# GENERATION PGM

**Re: Generation PGM ("GenPGM") Marathon Palladium Project ("Project")  
Environmental Impact Statement Addendum Appendix D4 (Hydrogeology Updated  
Effects Assessment Report) Figure Correction**

Figure No. **11**

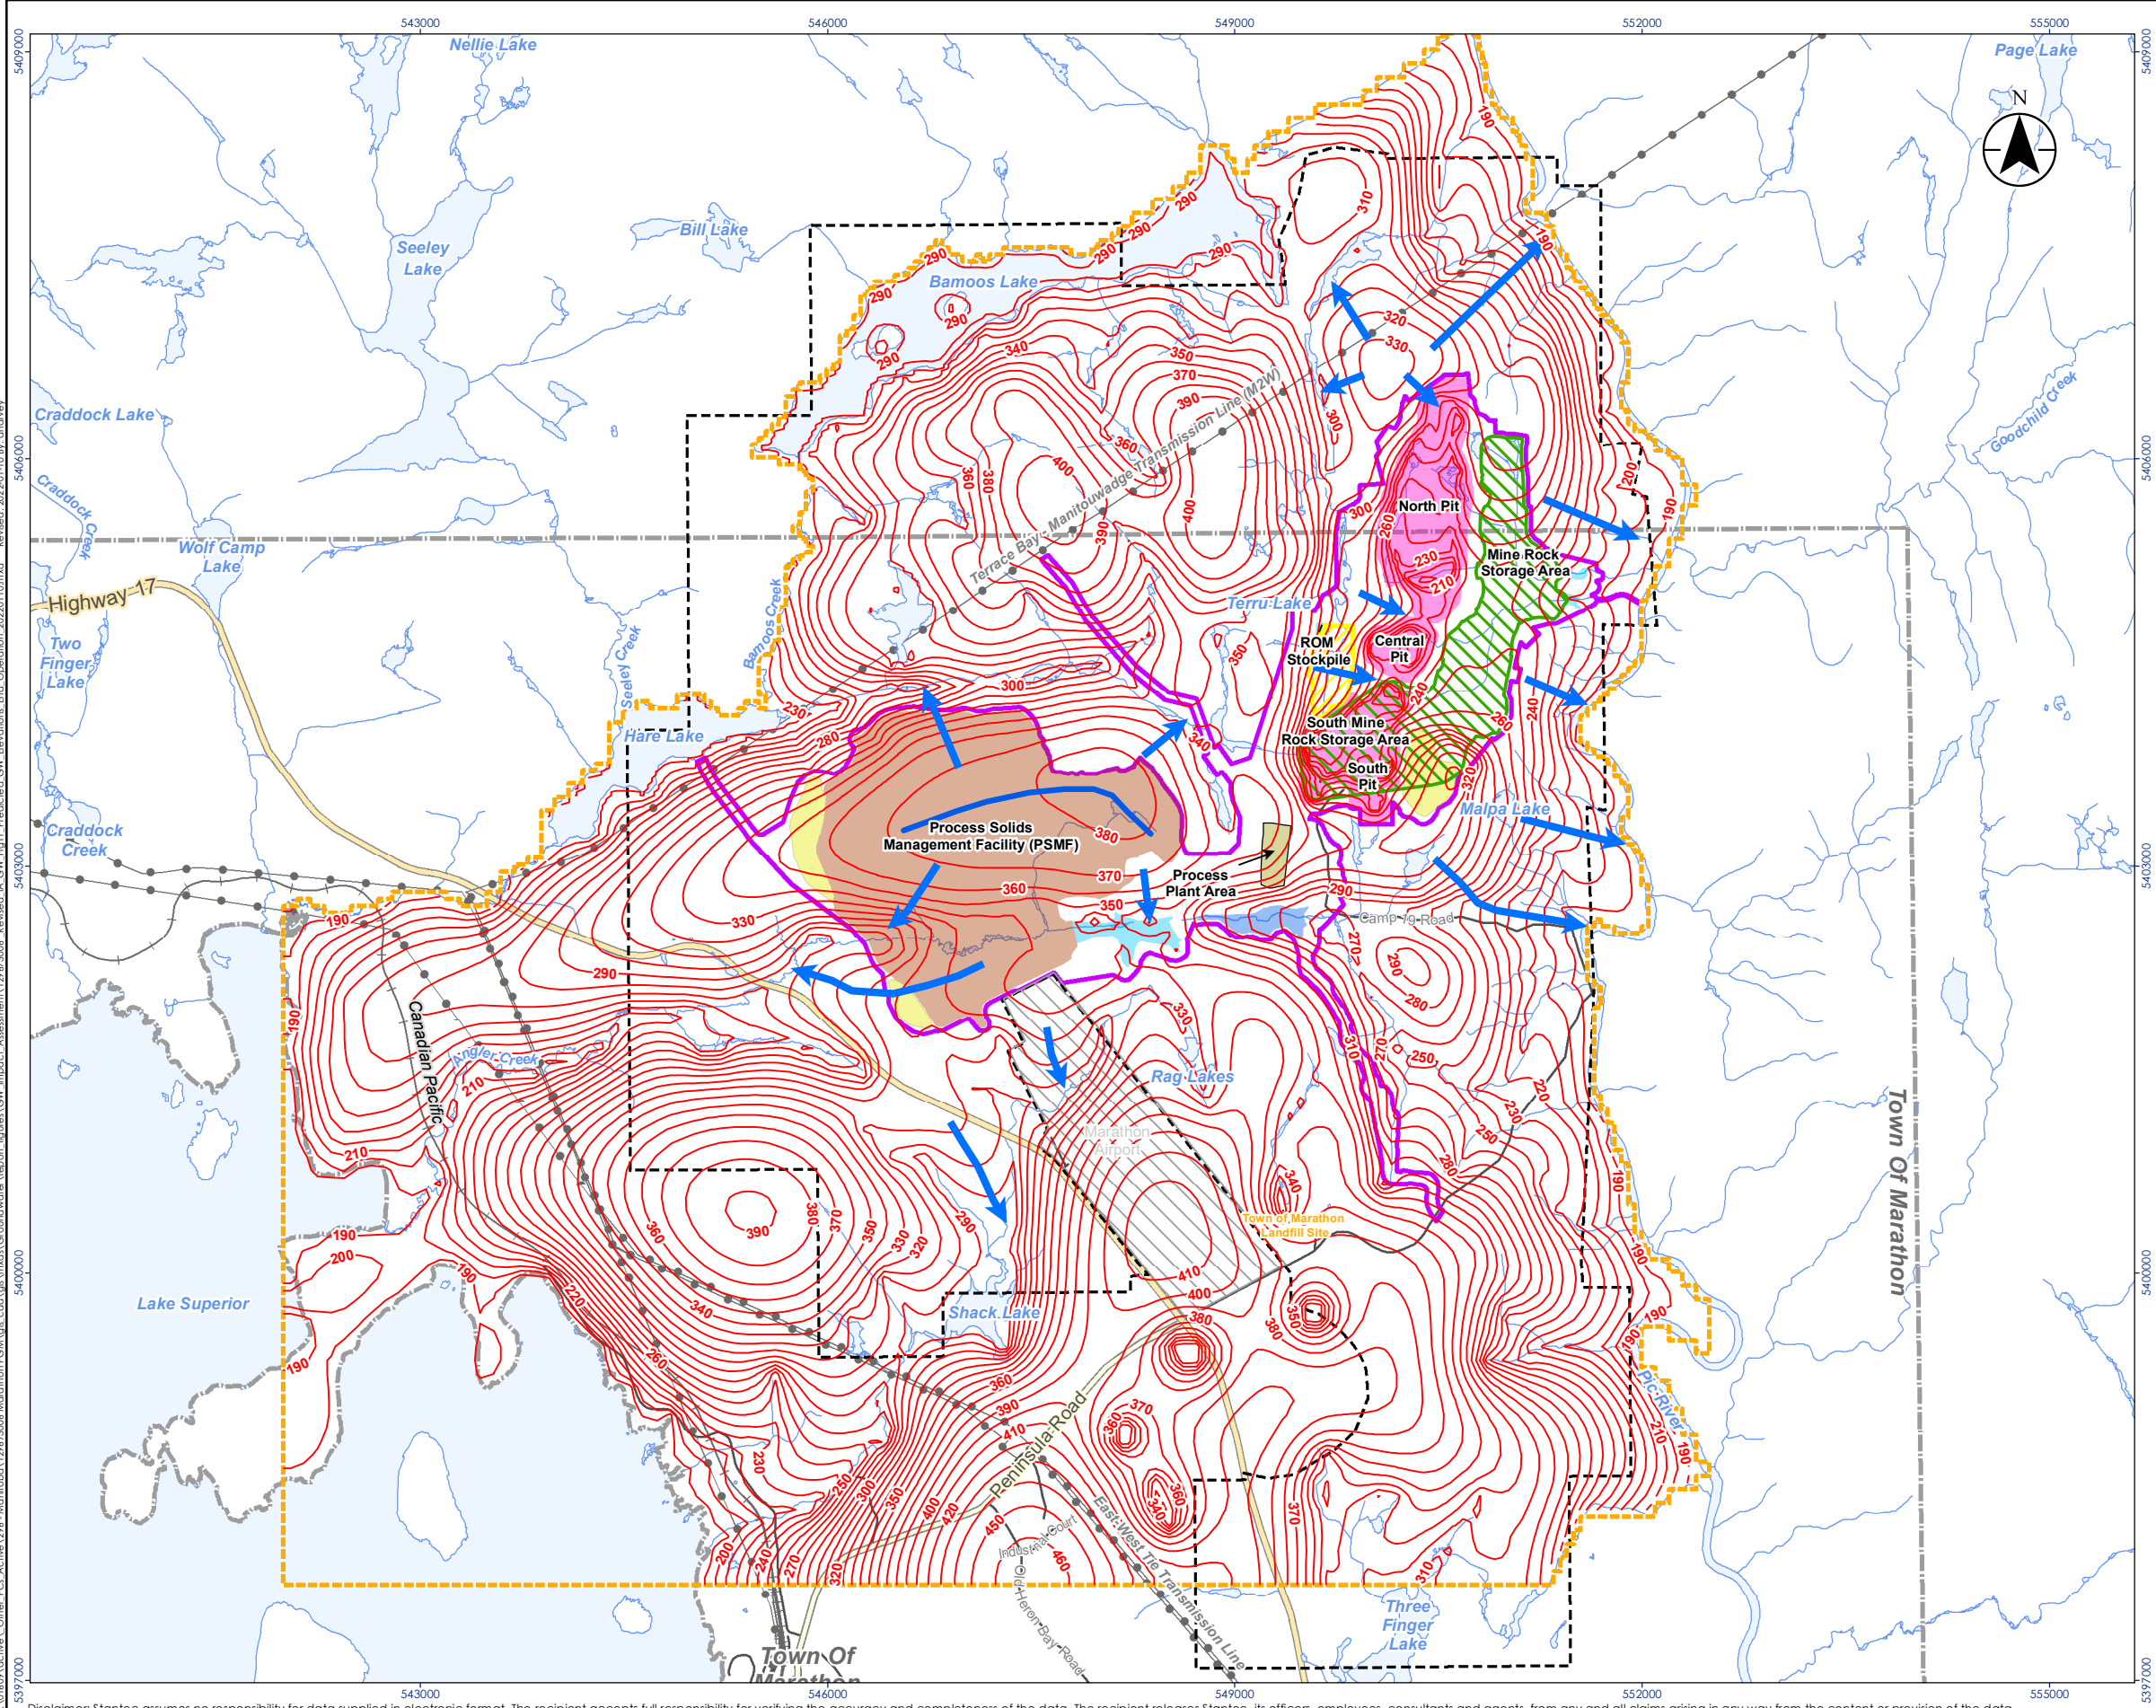
The simulated steady-state water table elevation contours for the end of operations (year 12 of mine life) and in closure were presented on Figure 11 (PDF 67) and Figure 13 (PDF 69), respectively, within Appendix D4 (Hydrogeology Updated Effects Assessment Report) of the EIS Addendum (CIAR #[727](#)). Two groundwater flow directional arrows on Figures 11 and 13, located south of the Process Solids Management Facility (PSMF), were inadvertently presented in the opposite direction of groundwater flow. The groundwater flow direction arrows in the vicinity of the PSMF have been updated and are presented on the attached revised Figure 11 and 13.

The groundwater flow direction arrows are not an output from the groundwater flow model and are placed on the figure to assist the reader in interpretation of the groundwater elevation contours. The prediction of groundwater discharge and particle tracks of seepage from mine facilities (such as the PSMF and Mine Rock Storage Area) are a direct output of the groundwater flow model which are based on the predicted groundwater elevation contours, which remain unchanged from the EIS Addendum. Therefore, the direction of the groundwater flow arrows do not affect the assessment of effects of the Project on groundwater as presented in the EIS Addendum.
